MOUNT JOY TOWNSHIP

LOT LINE CHANGE PLAN
JAMES W. AND DONNA J. COBLE
MOUNT JOY TOWNSHIP
LANCASTER COUNTY, PENNSYLVANIA

Re: James W. and Donna J. Coble
Lot Line Change Plan
Township Permit No. 26-28-LLCP
LCEC Project No: 25-220

We have received a lot line change plan submission from Hanover Engineering for the above-referenced project. The submission consisted of the following documents (received electronically September 8, 2026):

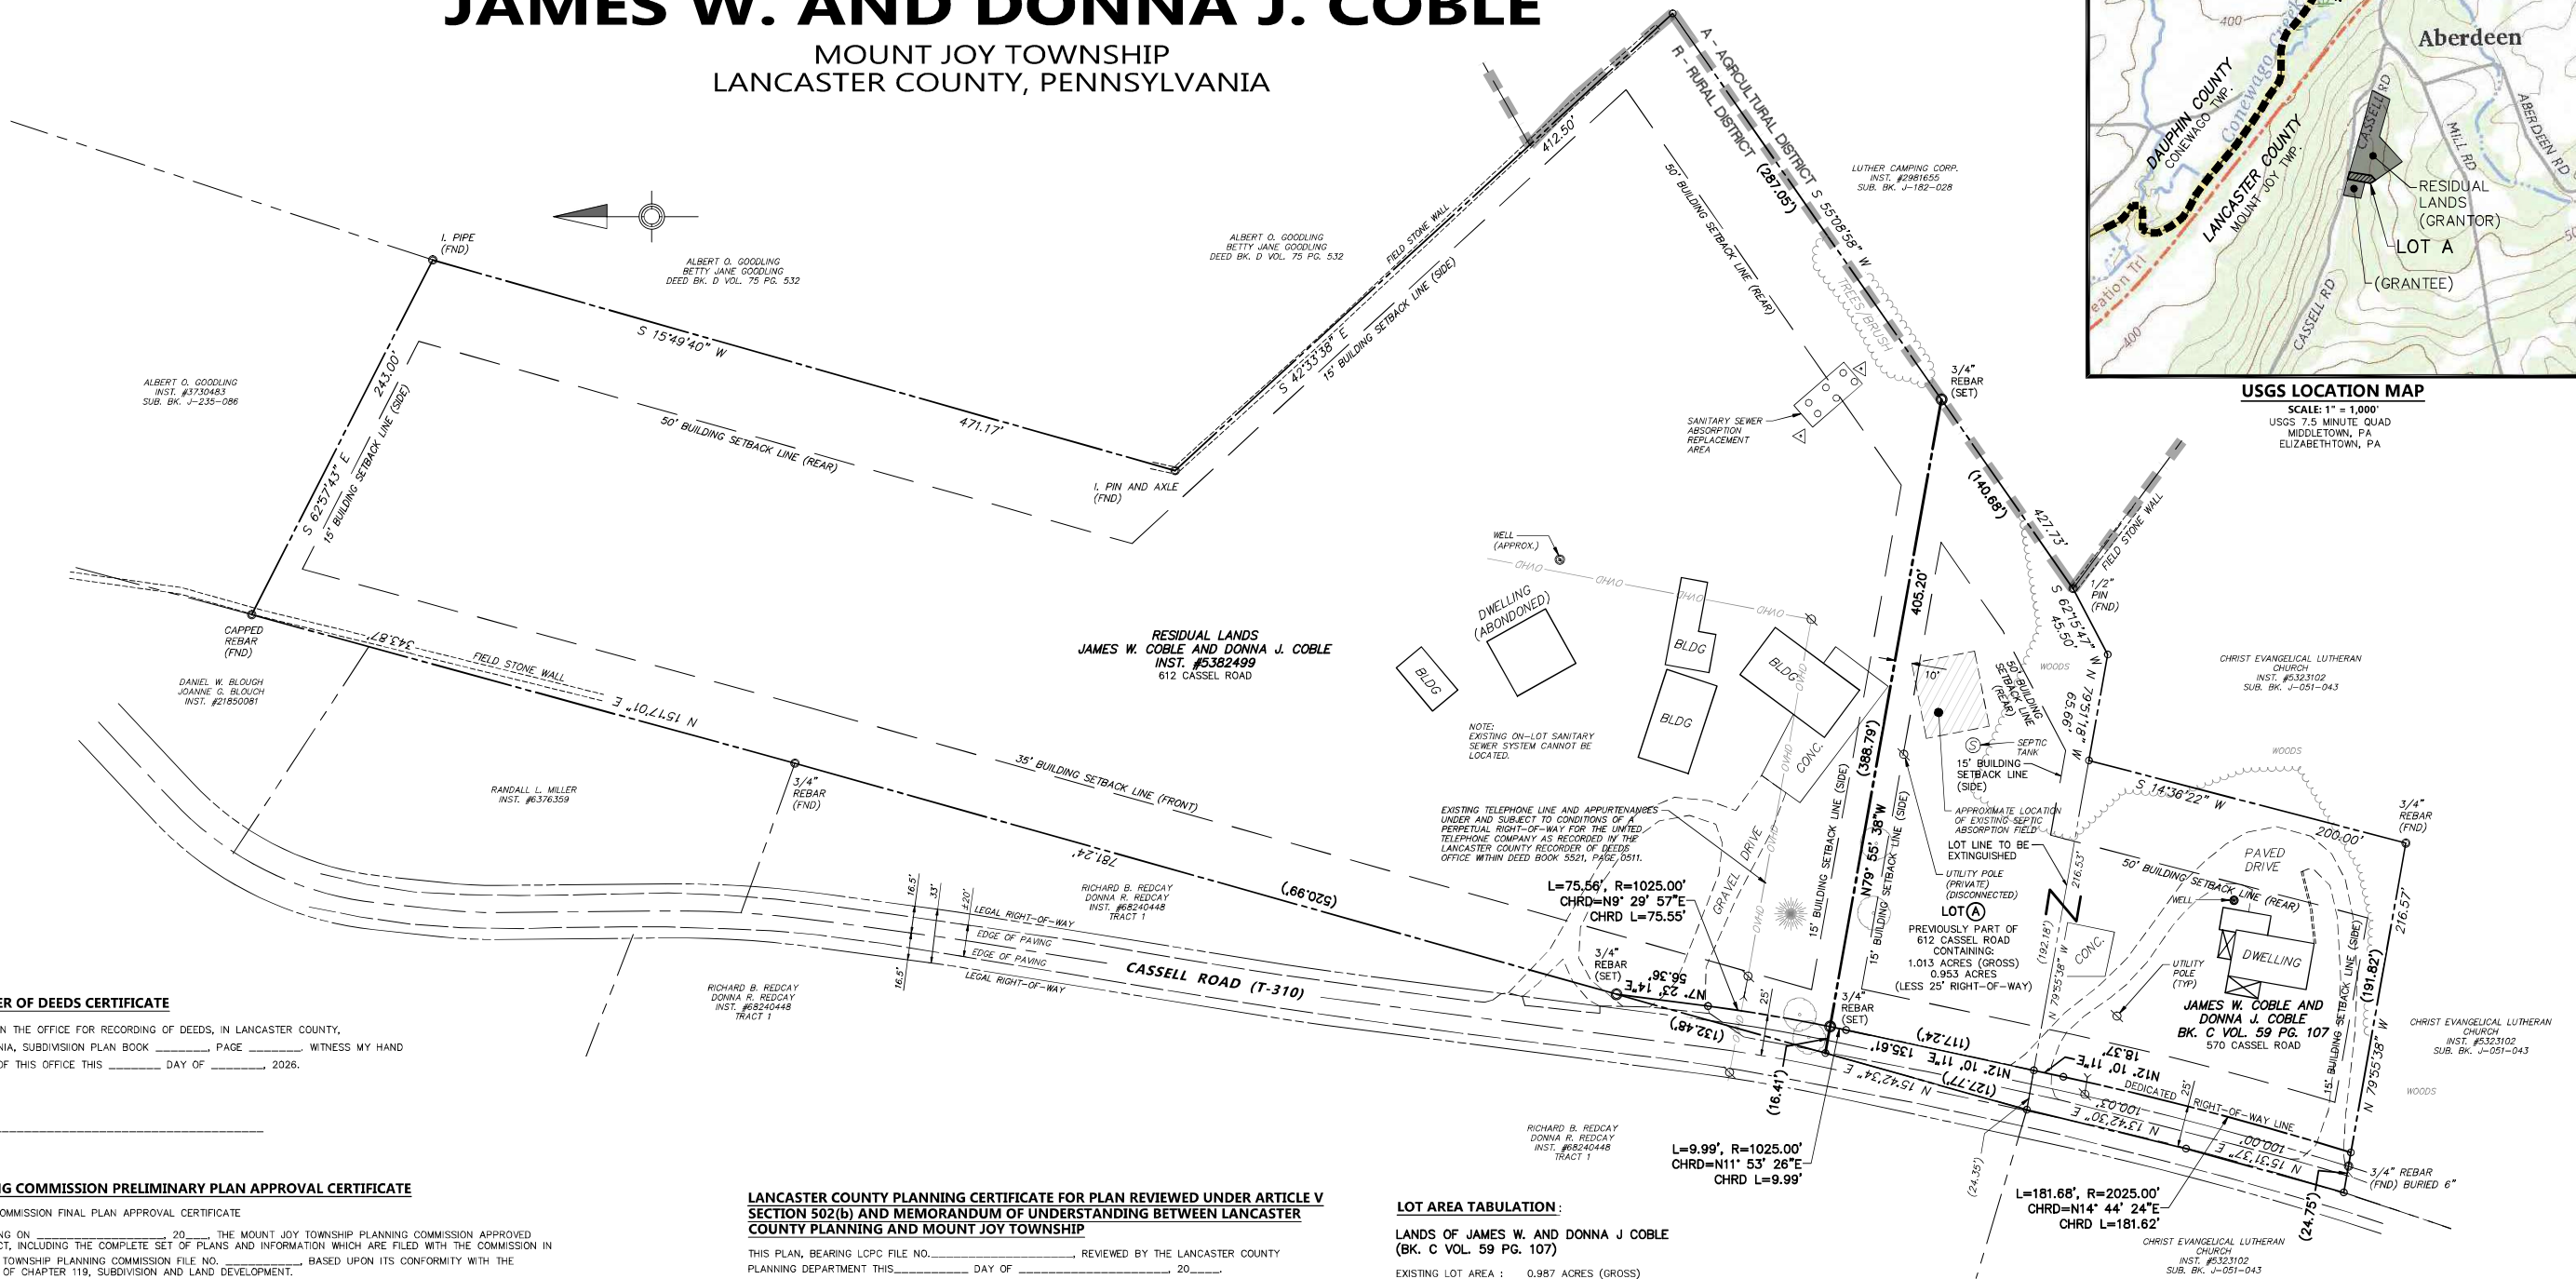
1. Clear sight triangles and required stopping sight distances shall be shown at the existing driveways (135-299.E(2), 119-31.D(12) & 119-52.L).
2. The required number of parking spaces for the existing uses shall be provided (135-343).

3. It is recommended that a linetype and symbol legend be added to the plans (119-31.A(4)).
4. The plans shall be signed and sealed by a registered engineer, surveyor or landscape architect (119-31.A(5)).
5. The tax parcel identification numbers shown in the "Source of Title" have been switched and shall be revised accordingly (119-31.B(10)).
6. The plan shall identify all prior plans, including all notes or restrictions affecting the current development, with a verification signed by the design professional that such list is complete and correct (119-31.B(14)).
7. The existing tract boundary of the 612 Cassell Road property shall be confirmed along its frontage with Cassell Road (119-31.B(17) & 119-31.C(2)). The recorded Redcay deed (Bk. 6824, Pg. 448) places the Redcay tract on the west side of Cassell Road - the opposite

side from 612 Cassell Road - based on its own courses and bearings; the LanCo View mapping is consistent with this. The plans as submitted show a portion of the Redcay property on the east side of Cassell Road, which is not supported by either source. This could result in an orphaned parcel between the Coble property and Cassell Road, which the applicant may want to resolve as part of this process.

8. The name and deed reference for the Miller property shall be updated (119-31.C(2)).
9. The total number of lots, units of occupancy, density, and land use shall be provided on the plans (119-31.D(3)).

10. Bearings and distances shall be provided for the existing right-of-way (119-31.D(4)).
11. The existing and proposed lot coverages should be added to the Zoning Data table (119-31.D(9)).

12. The existing and proposed lot widths and lot depths for each lot shall be provided (119-31.D(9)).
13. The plans shall indicate when the lot line markers are to be set (119-31.D(14)(a) & 119-57.H).

14. A wetlands study shall be provided (119-35.E(3)(c)).
15. All certificates shall be executed prior to final plan approval (119-35.E).
16. Written notice shall be provided from the DEP that approval of the sewer planning module has been granted or notice from the Department that such approval is not required (119-35.E(2)(a) & 119-60.A).

17. Legal descriptions for the right-of-way proposed for dedication to Mount Joy Township shall be provided (119-35.E(4)(b)).
18. A land development agreement in a form acceptable to the Township Solicitor shall be executed (119-35.E(4)(f)). If the required lot markers and monuments are set prior to the recording of the plan, and the plan is revised to include the set markers and monuments, then a land development agreement would not be needed.

20. The Recorder of Deeds Certificate shall be removed. The Lancaster Recorder of Deeds will apply a header along the top of the plan (typically within the first inch) when it is recorded. It is advised to leave a 1¼" margin along the top of the plan sheet to avoid having information covered by this header (119-36.A).

22. The frontage along Cassell Road (local street) shall be improved in accordance with 119-52.J or as indicated on the Township Official Map, whichever is greater. The existing cartway is shown as 20 feet wide; the required cartway width for a local street outside of the designated growth area is 20 feet with 2-foot paved shoulders (24 feet total) (119-52.J(3)(a)).
